**Project #16-040
Hampton Inn & Suites
Located at the northwest corner of
Main Street and 200 North**

Project Name: Hampton Inn & Suites
Proponent / Owner: Matt Weston / Logan City
Project Address: Approximately 233 North Main Street
Request: Design Review Permit
Current Zoning: Town Center (TC)
Type of Action: Quasi-Judicial
Date of Hearing: October 13, 2016
Submitted By: Amber Pollan, Senior Planner

Staff recommends that the Planning Commission **conditionally approve** a Design Review Permit for Project #16-040, Hampton Inn & Suites, for the property located at approximately 233 North Main Street, TIN# 06-016-0034.

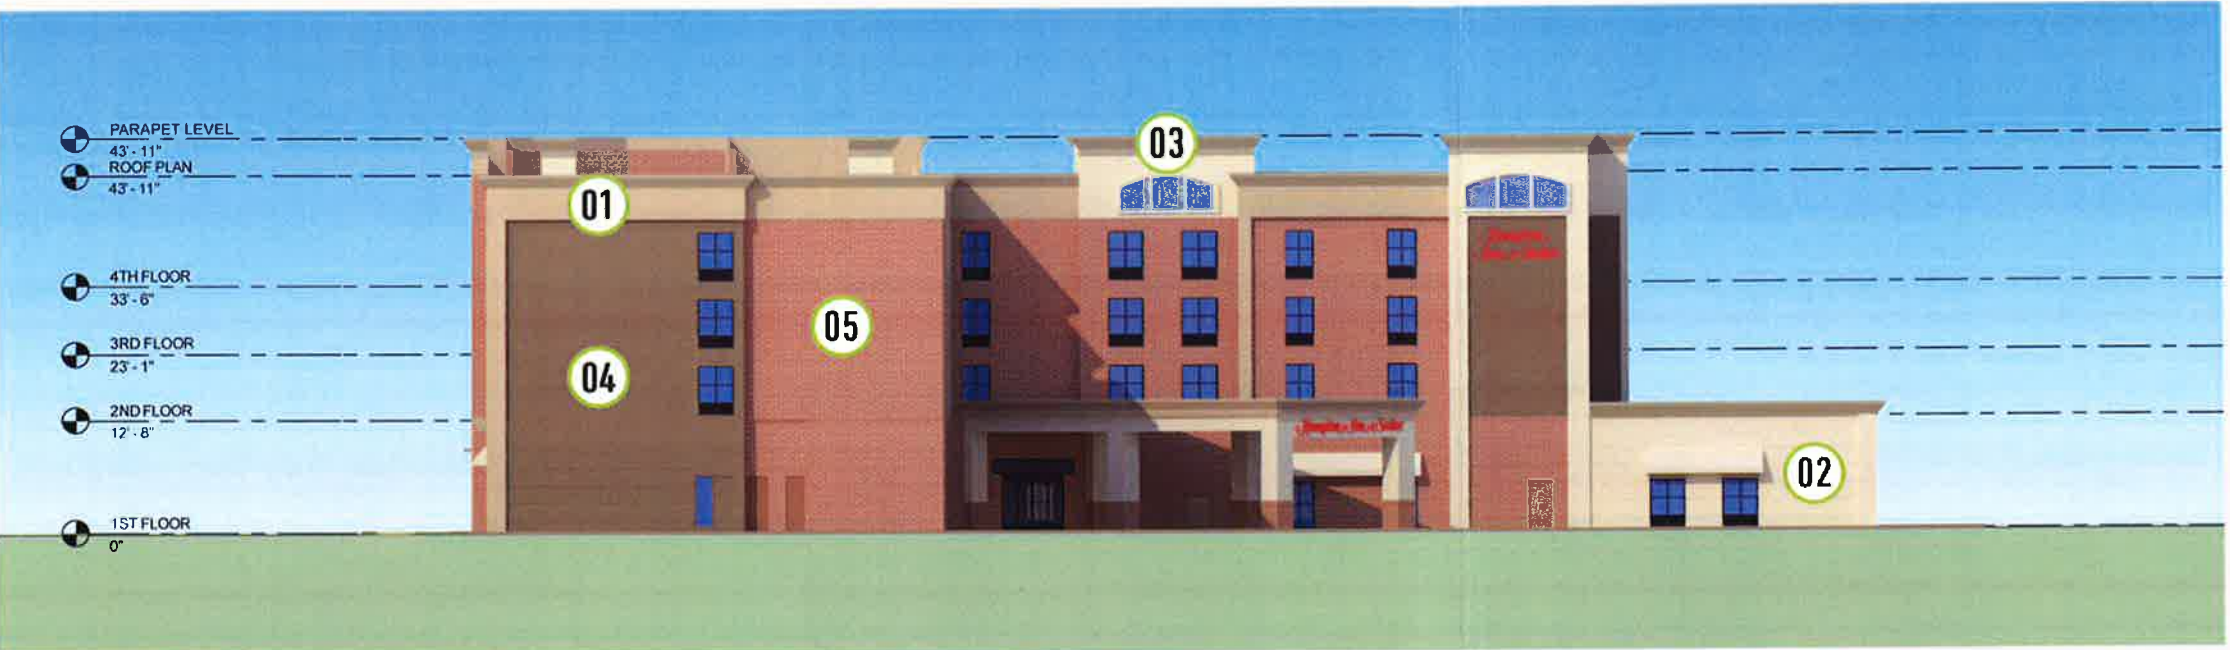
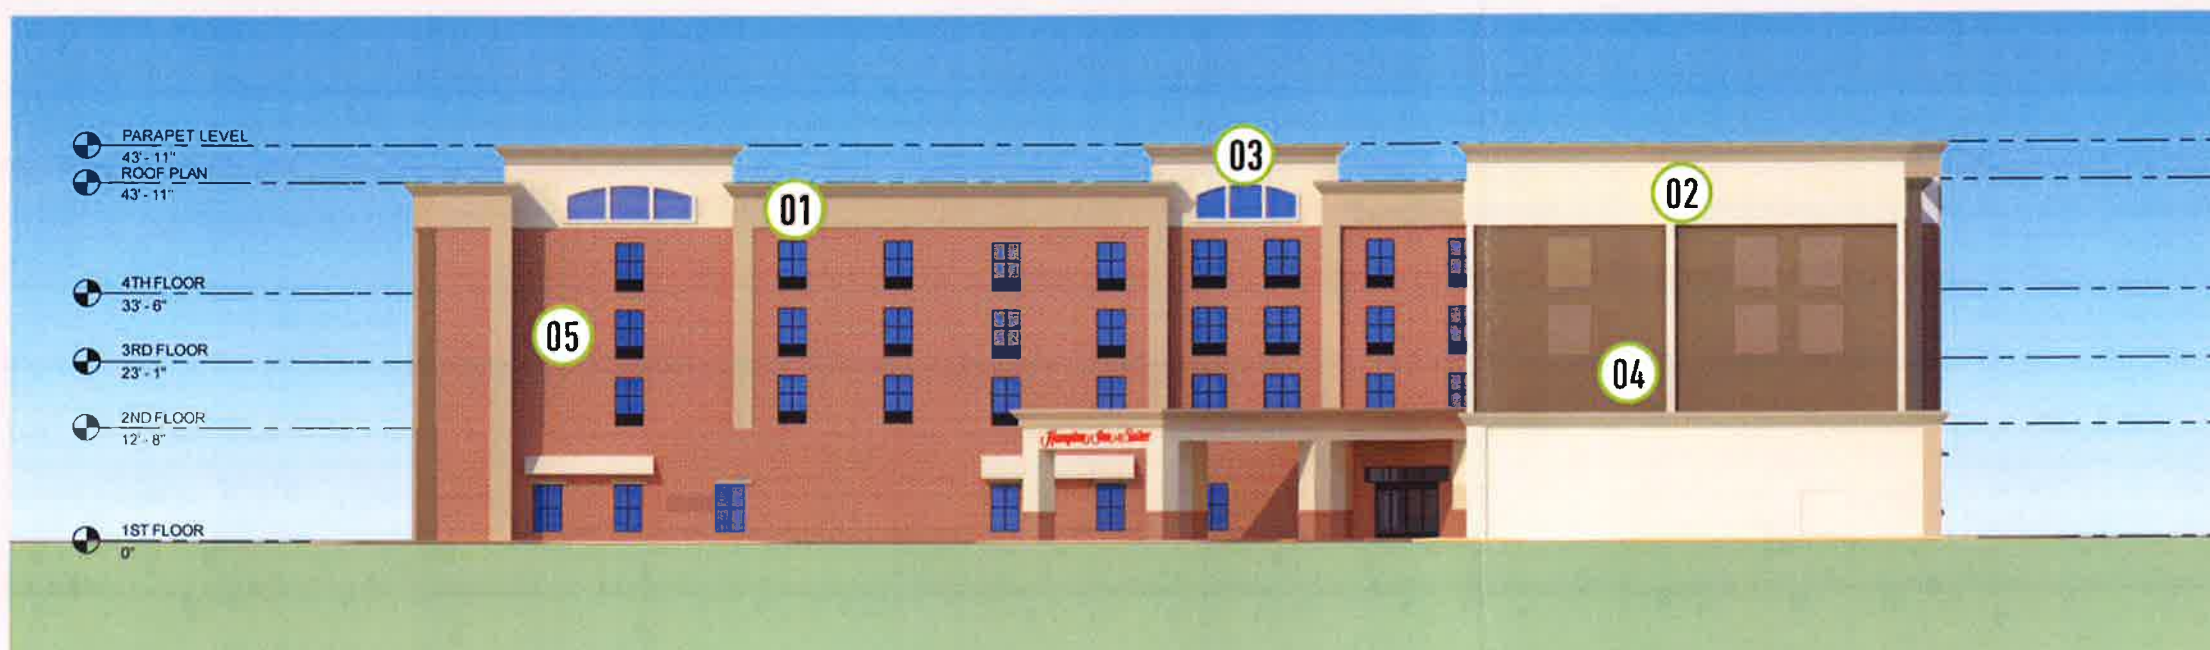
elevations indicate primarily the use of brick. The applicant has indicated that they would like to vary the material more on the interior. Staff recommends that brick be used as a minimum for the first floor or in vertical sections, alternating with building sections like the frontage elevations. As conditioned with detail on the EIFS material, the project meets the building material requirements of the Land Development Code.

8. If the north and west interior elevations are modified, brick shall be used first floor, as a minimum, or in vertical sections, alternating with building sections like the frontage elevations.

East Elevation

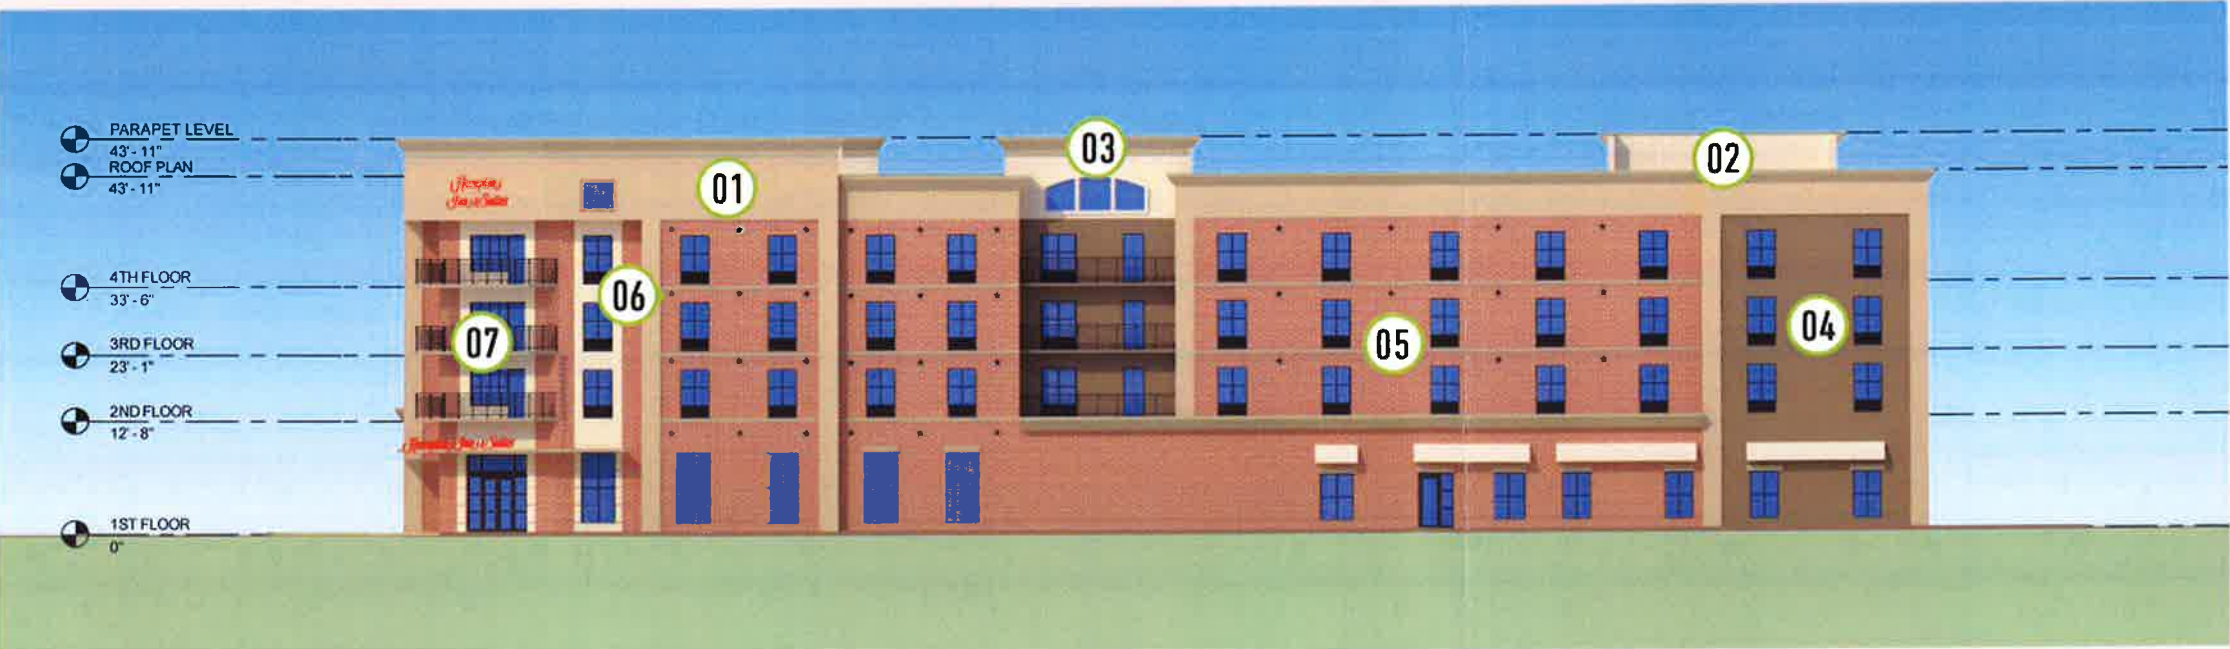
In the TC zone, blank wall lengths of 30' are prohibited. There is an area of the Main Street frontage that is 50' long and does not have variation. The LDC also requires a minimum of 60% transparency/fenestration on ground-floor facades and 20% for upper floors in the TC zoning district. Fenestration is defined as variation in the arrangement and detailing of windows and other openings. The upper floors do provide more than 20% transparency in windows. The ground floor is at approximately 36% transparency (windows) on the Main Street elevation. The elevations provided did not have a scale; Staff will provide detailed percentages at the meeting. Additional transparency on the Main Street side would resolve the blank wall length and add to the percentage. The awnings and modulation of wall planes do add to the intent of the fenestration of the wall plane. The project may be found to be compliant. Staff recommends substantial conformance with the transparency/fenestration requirements and maximum blank wall length of 30' be applied.

5. Weather protection required for ground floor entrances.
6. Building elevations shall provide substantial conformance with the transparency/fenestration and building wall length articulation requirements.

South Elevation

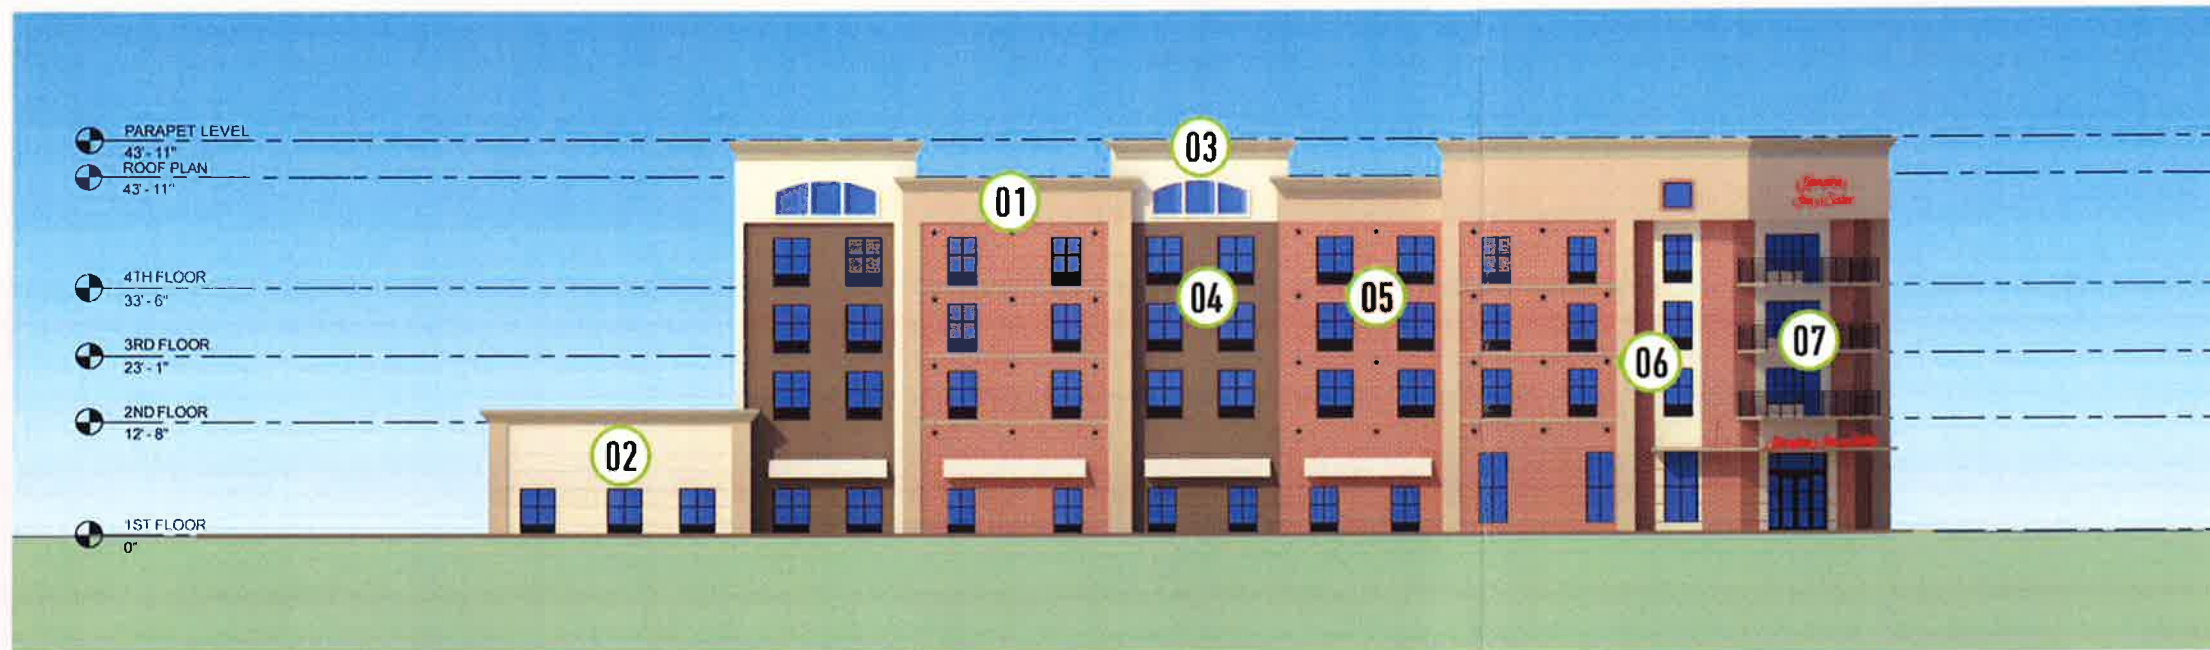
The Main Street front, North and West Sides of the building are substantially compliant with setback standards. The South/200 North building elevation has some variation in the wall plane that includes two 20' wide sections that extend 6.73' back. There are awning features on these areas that are within the setback. Staff recommends that the 6.73' setback be acceptable as it allows additional wall plane variation and still has architectural elements that are within the setback range. The intent of the building footprint being oriented to the street is being met.

4. The project development utilizes existing utilities, infrastructure, and roadways.
5. The 6.73' setback is found to be acceptable as it allows additional wall plane variation and still has architectural elements that are within the setback range.
